R25-077-02

**WESTMORELAND COUNTY HOUSING AUTHORITY
JEANNETTE MANOR ROOF REPLACEMENT**

ADDENDUM NO. 1

DATE OF ISSUE: October 16, 2025

A1.01

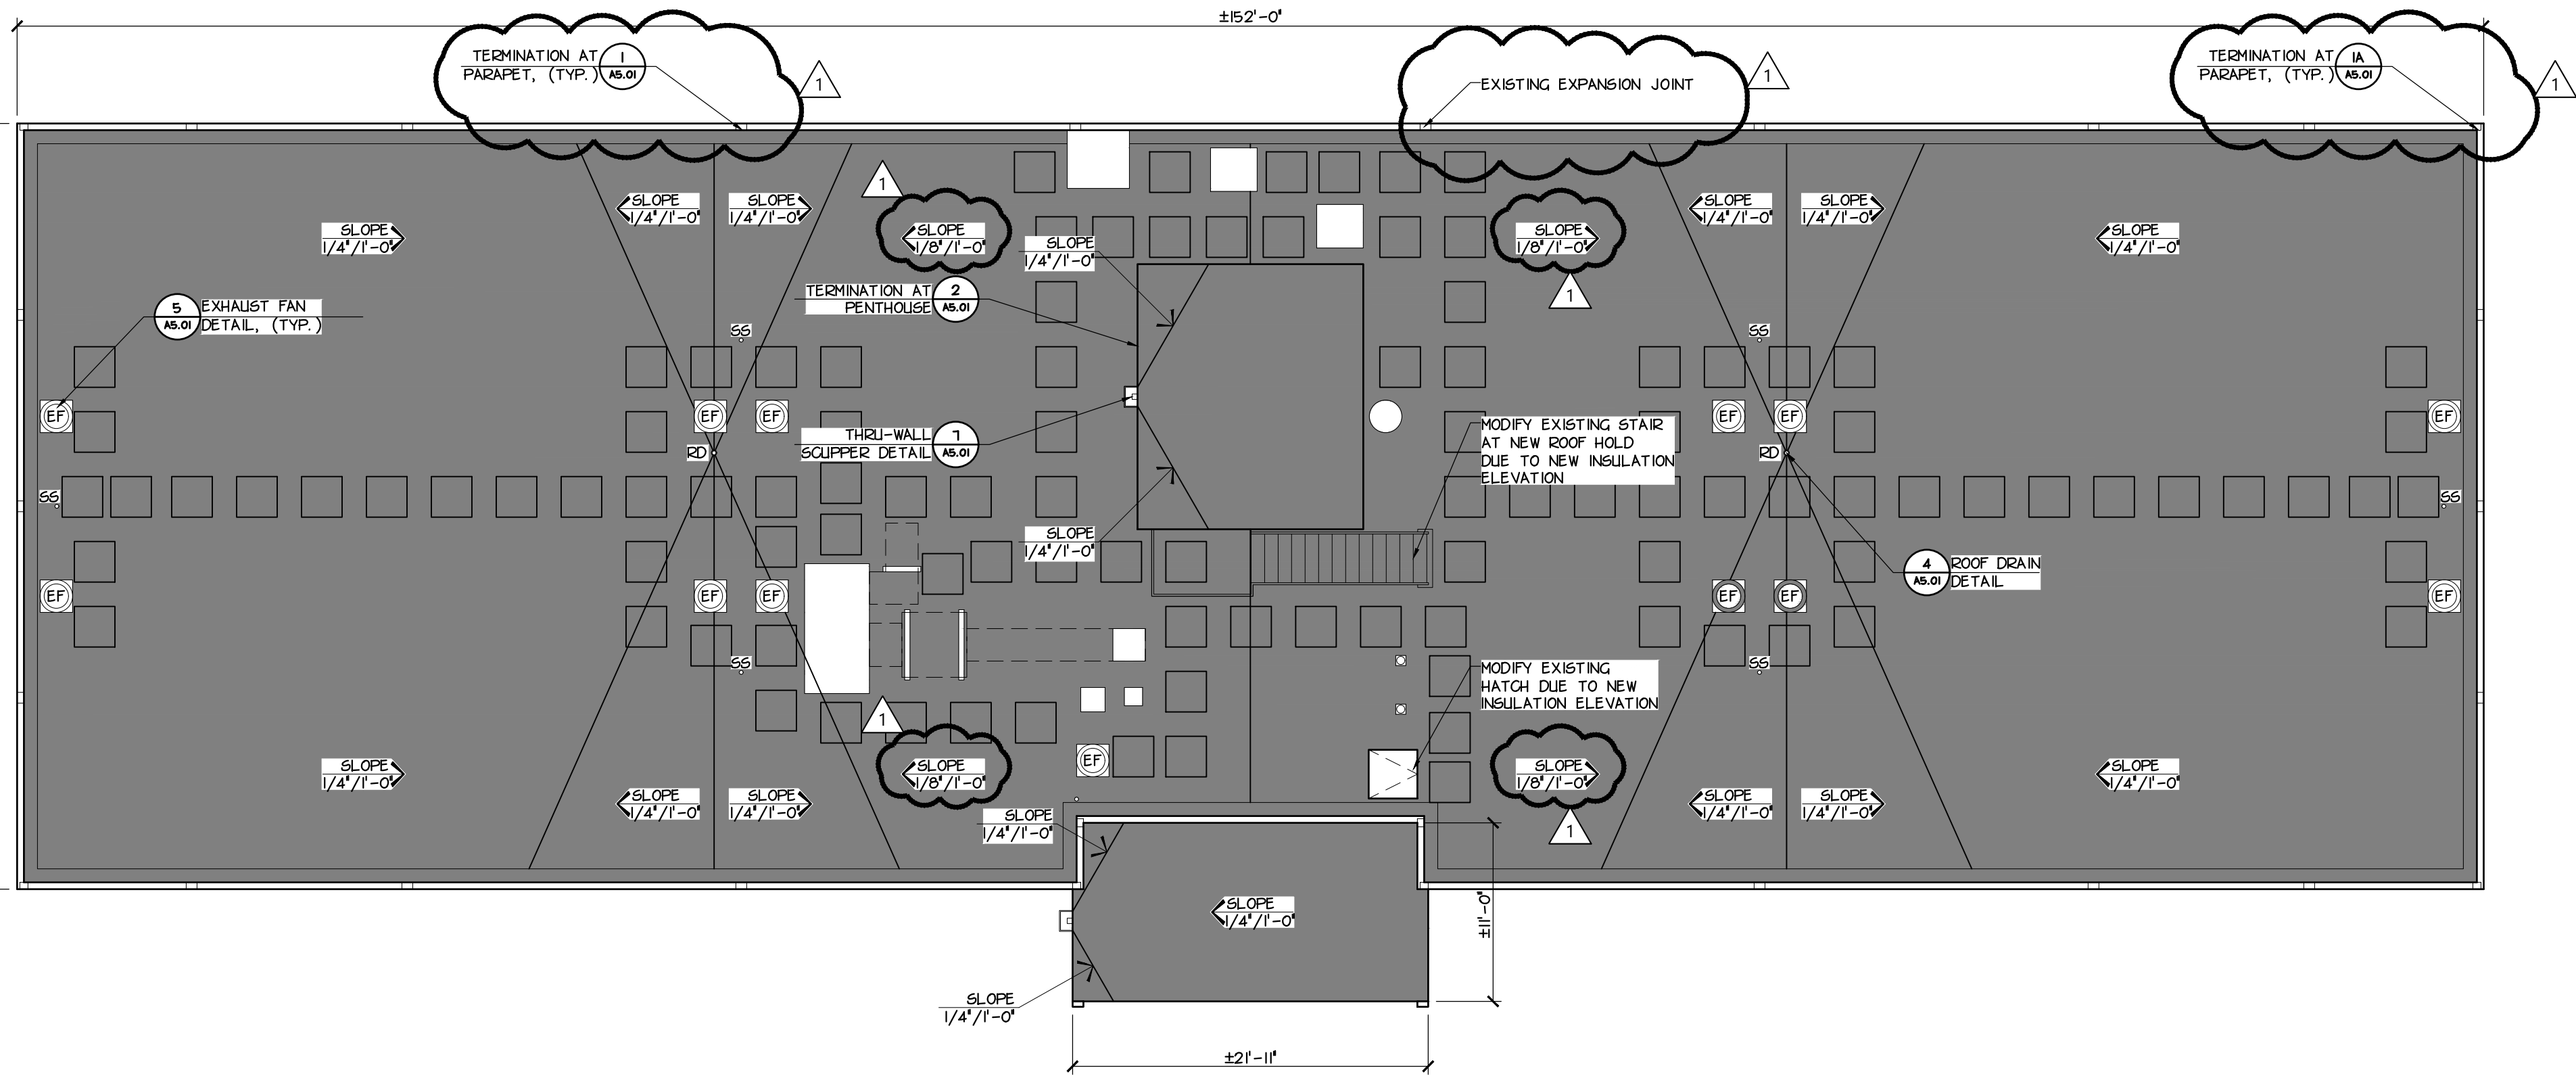
A1.01 ROOF PLAN

Revise the slope of tapered insulation as indicated on the attached revised drawing.

Add flashing and coping over existing expansion joint as indicated on the attached revised drawing.

A5.01

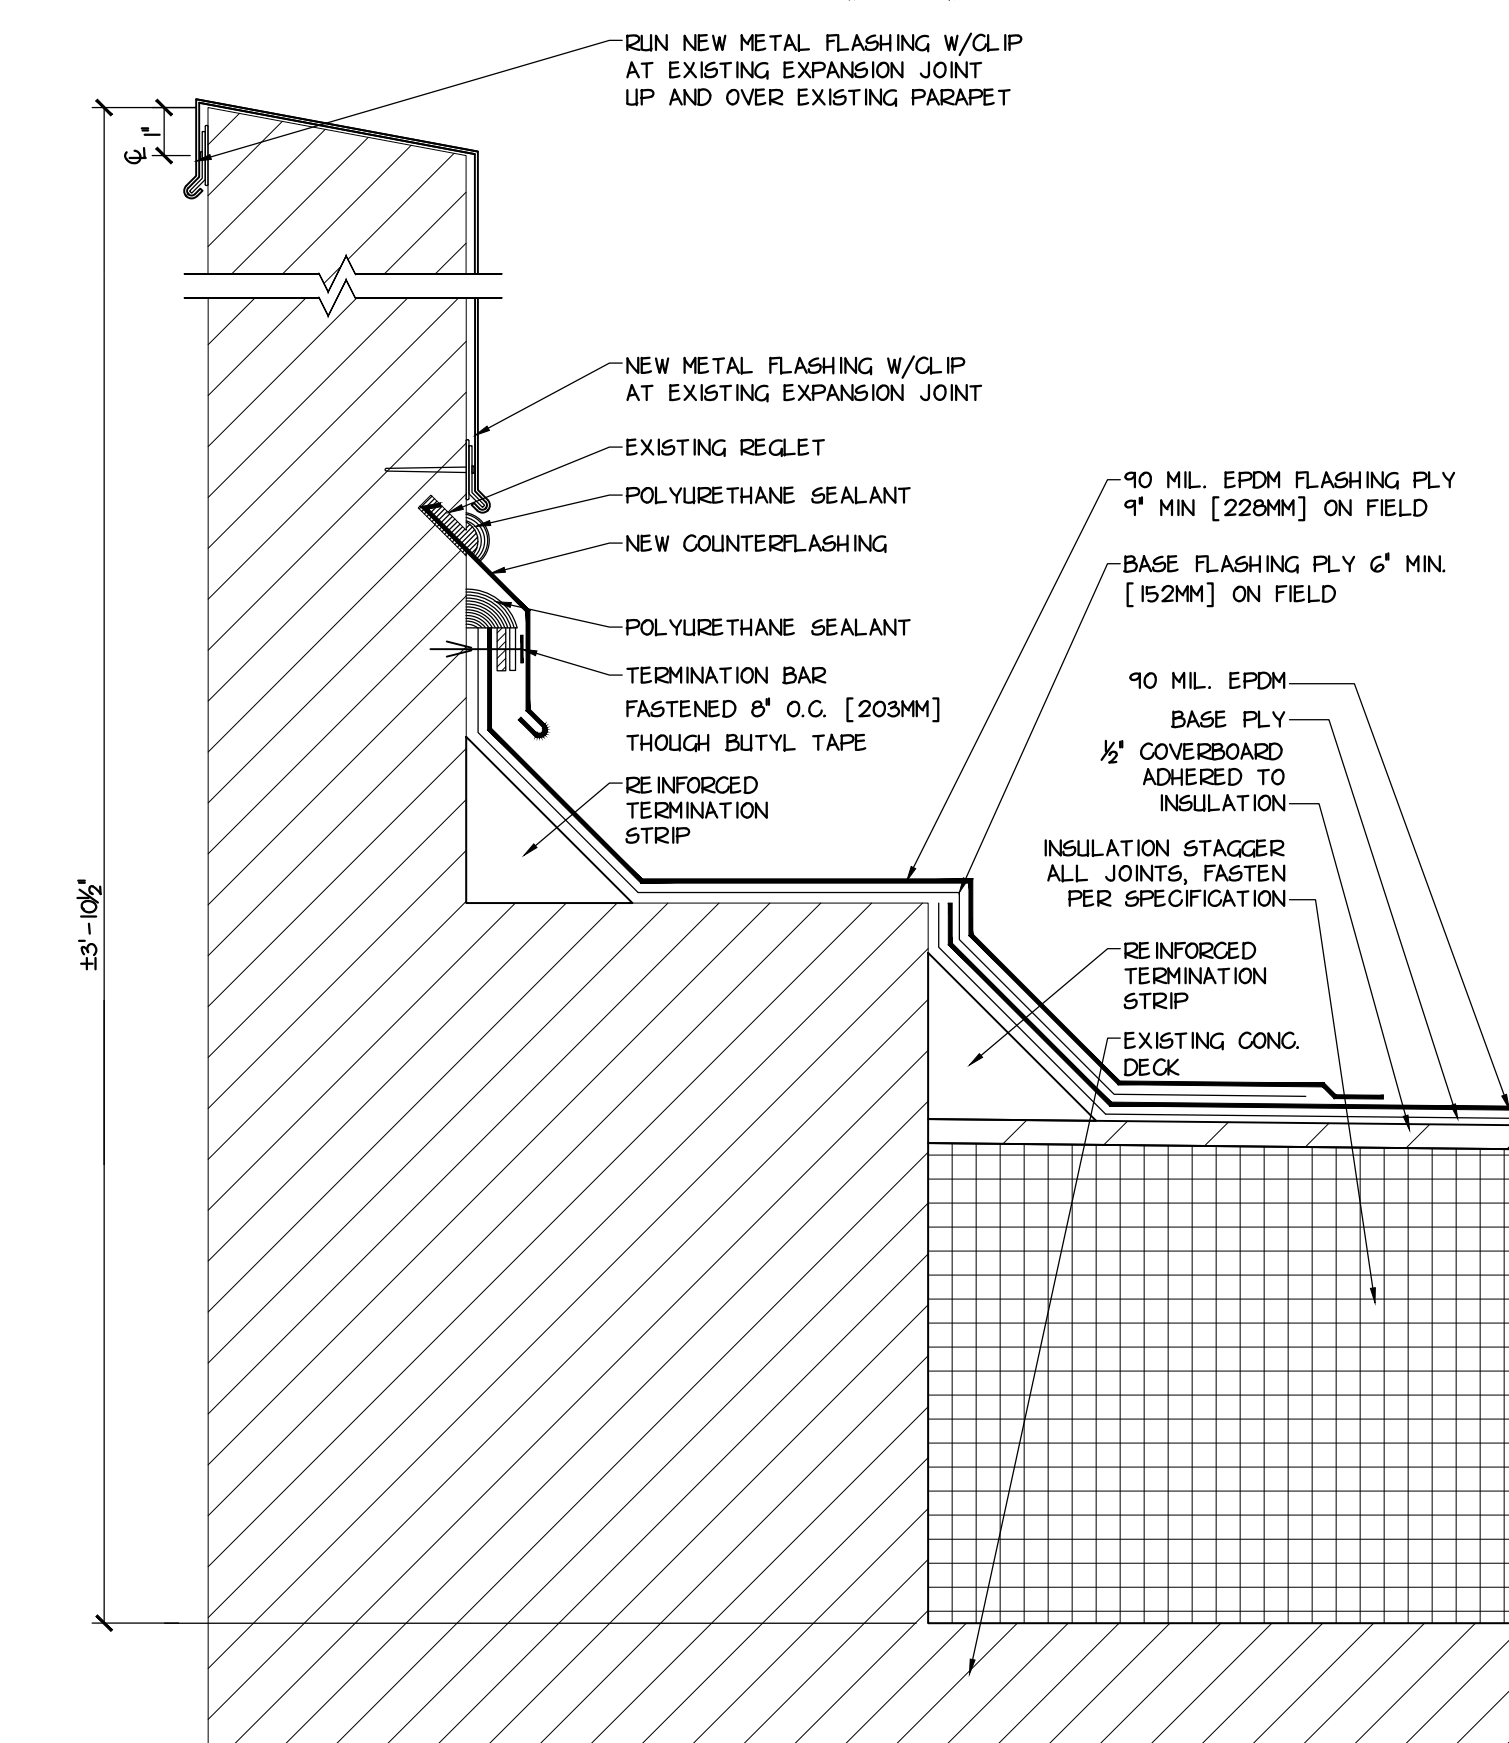
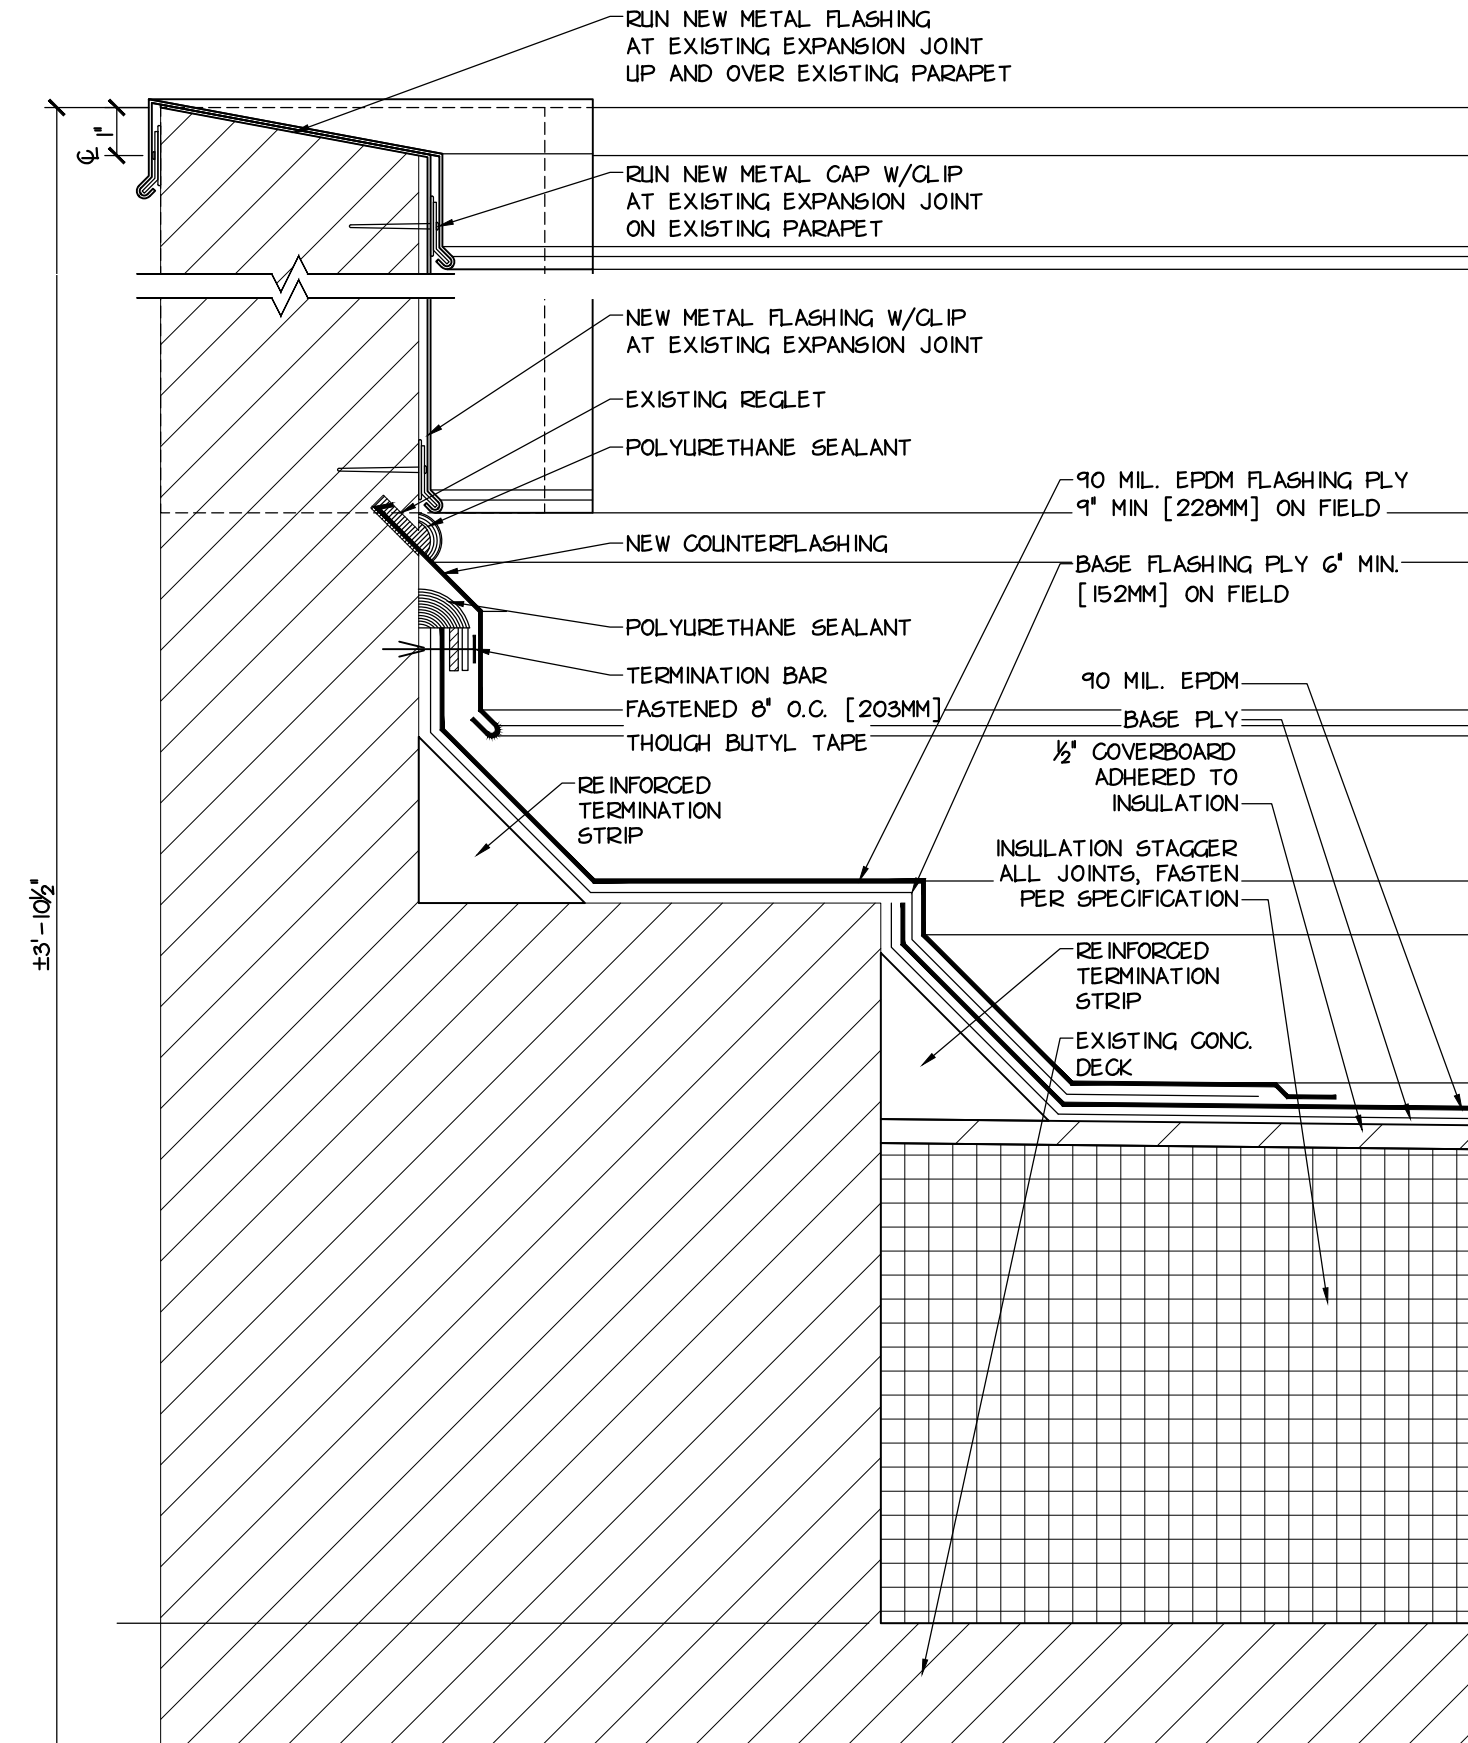
A5.01 ROOF DETAILS

Add flashing and coping over existing expansion joint as indicated on the attached revised drawing.
